STAFF RECOMMENDATION 143 Windsor Drive November 18, 2015

Application: New construction – outbuilding; Setback determination
District: Belle Meade Links Triangle Neighborhood Conservation Zoning Overlay
Council District: 23
Map and Parcel Number: 13001008500
Applicant: Kaitlyn Smous Architect
Project Lead: Sean Alexander, sean.alexander@nashville.gov

Description of Project: The proposal is to construct a one and one-half story outbuilding with a rear setback determination from 20' to 4'.

Site Plan

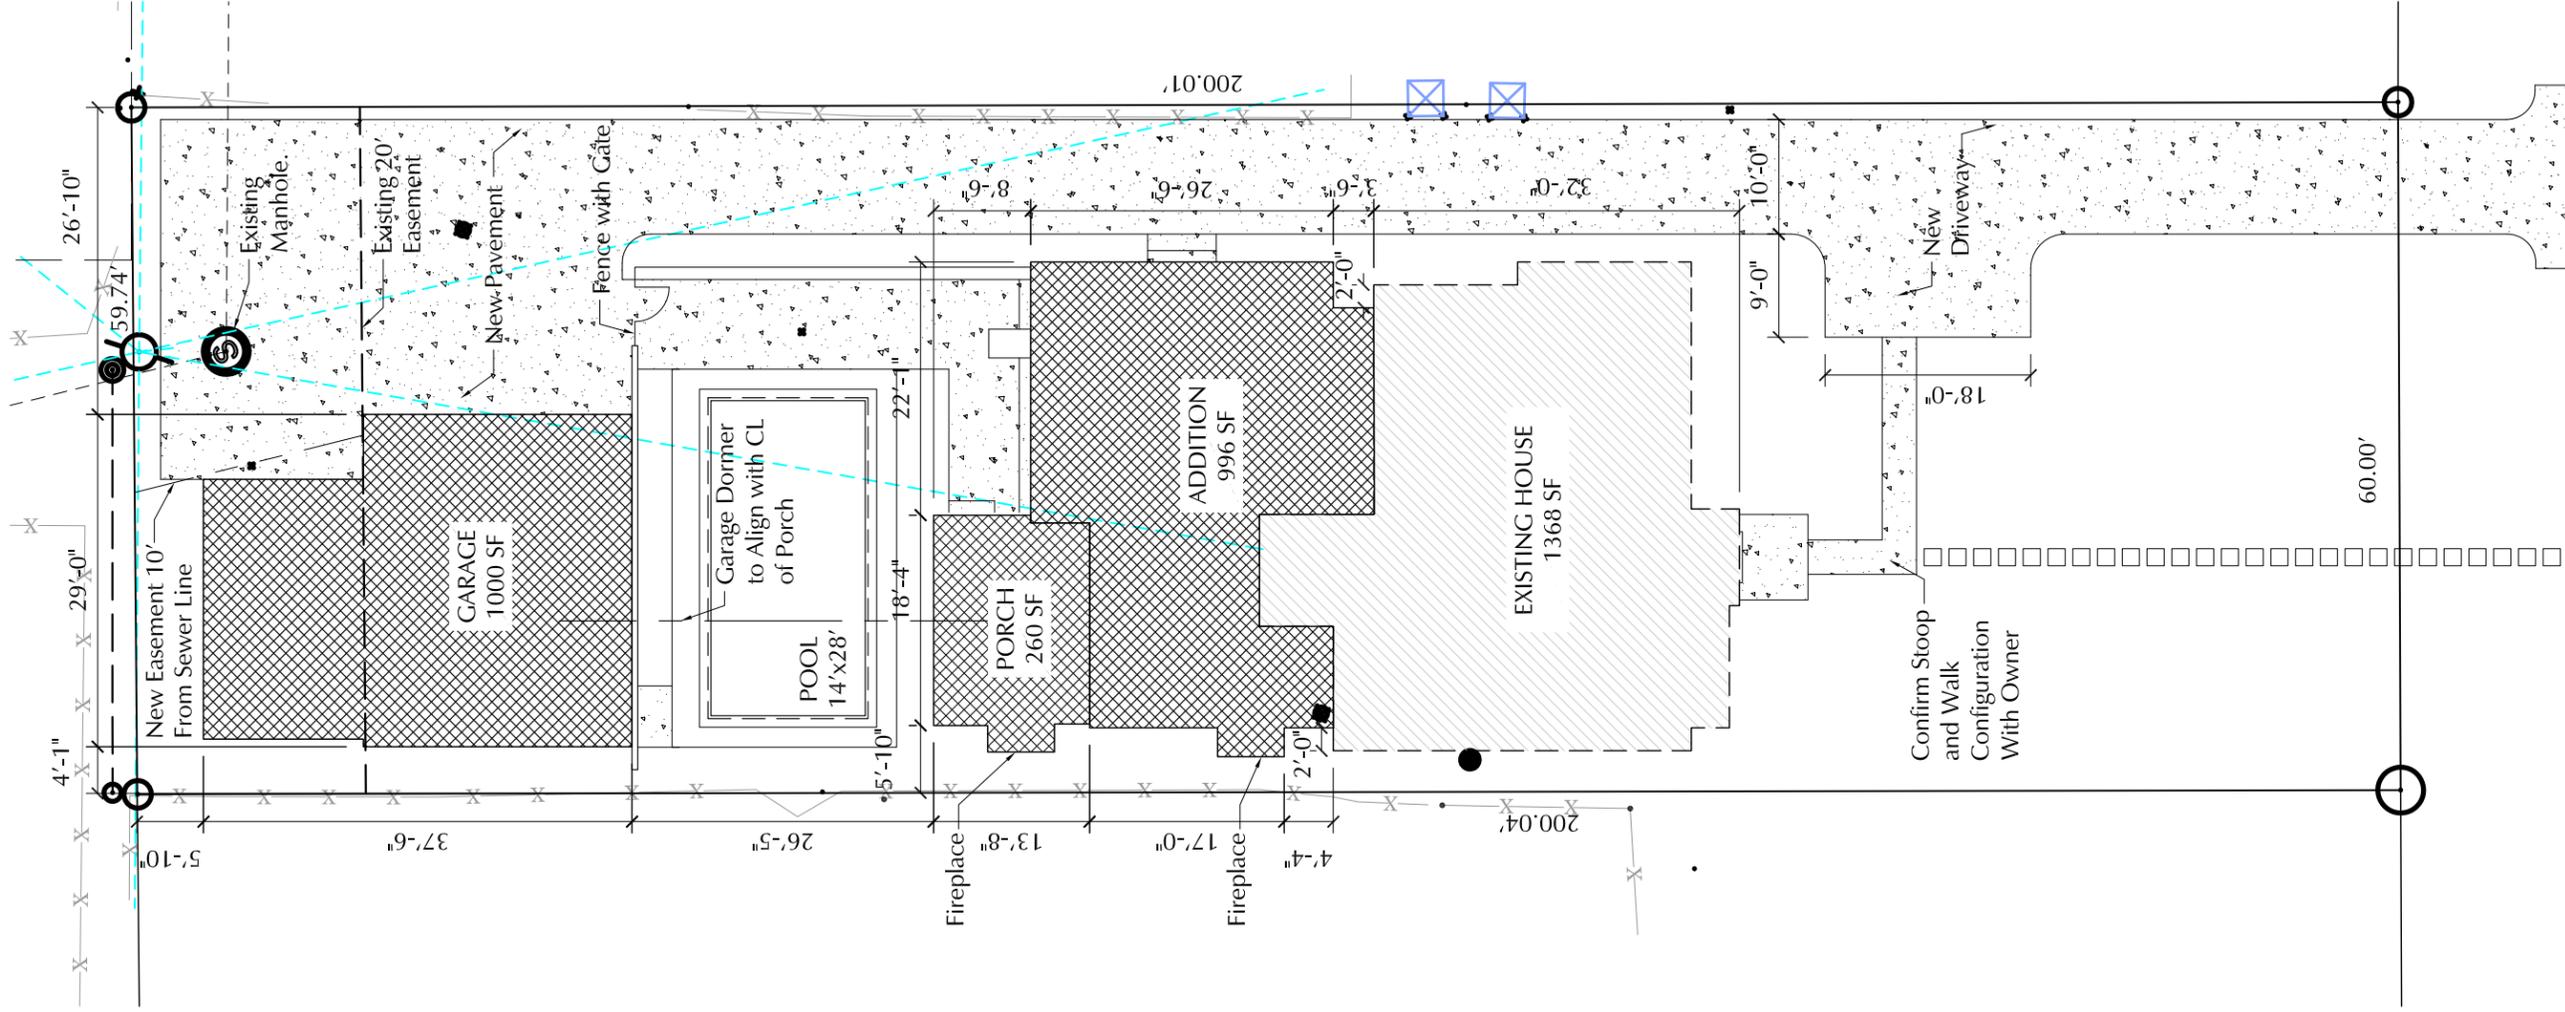
Location & Setbacks: The new outbuilding does require a rear setback determination. When an outbuilding has a footprint greater than seven hundred square feet (700 sq. ft.), base zoning requires that the structure be located twenty feet (20’) from the rear property line and five feet (5’) from the side property lines. In this instance, the structure will be located four feet (4’) from the left side property line and five feet (5’) from the rear property line.

Staff finds that the proposed setbacks are appropriate because historically outbuildings were located at the rear of the property, close to the property line. There is not an alley behind the lot, so the garage will be accessed from the street by an existing driveway.

Staff finds the location of the proposed outbuilding to be appropriate and recommends approval of the setback determination.

Drawings:
Garage Elevations
Date:
10.28.15

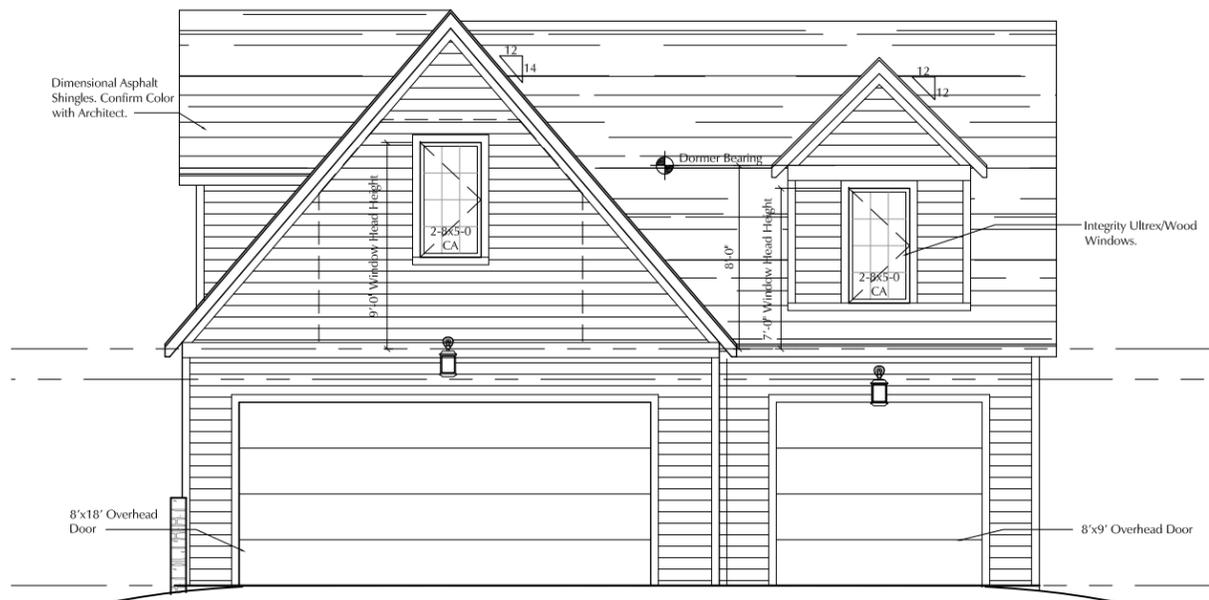
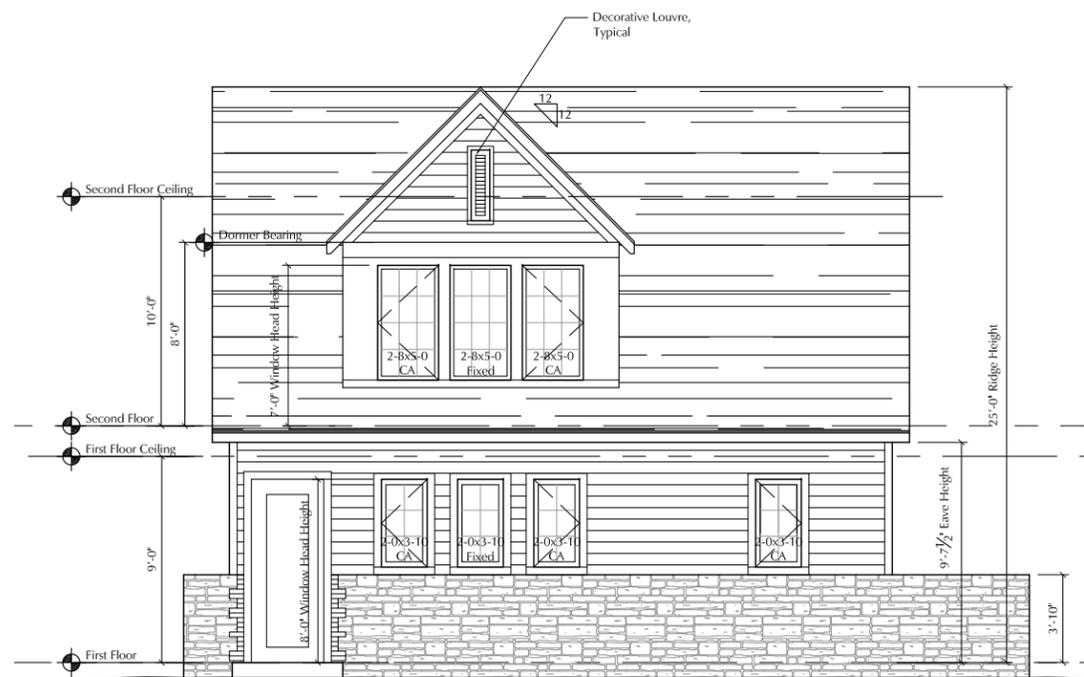
The proposed outbuilding will be one-and-a-half stories tall with a footprint of one thousand square feet (1000 sq. ft.). Staff finds this footprint to be appropriate since the lot is eleven thousand square feet (11,000 sq. ft.) in area. The outbuilding’s eave and ridge heights will be lower than those of the historic house.

Materials: The materials for the outbuilding have all been approved by the Commission in the past. The primary cladding material will be wood lap siding with a five inch (5”) reveal. Other materials include cement-fiber trim, stone veneer, fiberglass-clad wood windows, poured concrete foundation, and an asphalt shingle roof to match the house. Staff asks to approve the window and door selections and a stone sample prior to purchase.

Roof form: The roof of the addition will be a cross gable, which is compatible with the form and pitch of the existing primary roof. The north and east slopes of the roof will have gabled dormers. The dormer wall will sit one foot (1’) back from the first story walls below; this is appropriate because the building will not be a detached accessory dwelling unit. Staff finds this to be compatible and to meet section II.B.1.e of the design guidelines.

1. Staff shall approve the final details, dimensions and materials of windows and doors prior to purchase and installation; and,
2. Staff shall approve the roof color and masonry selection.
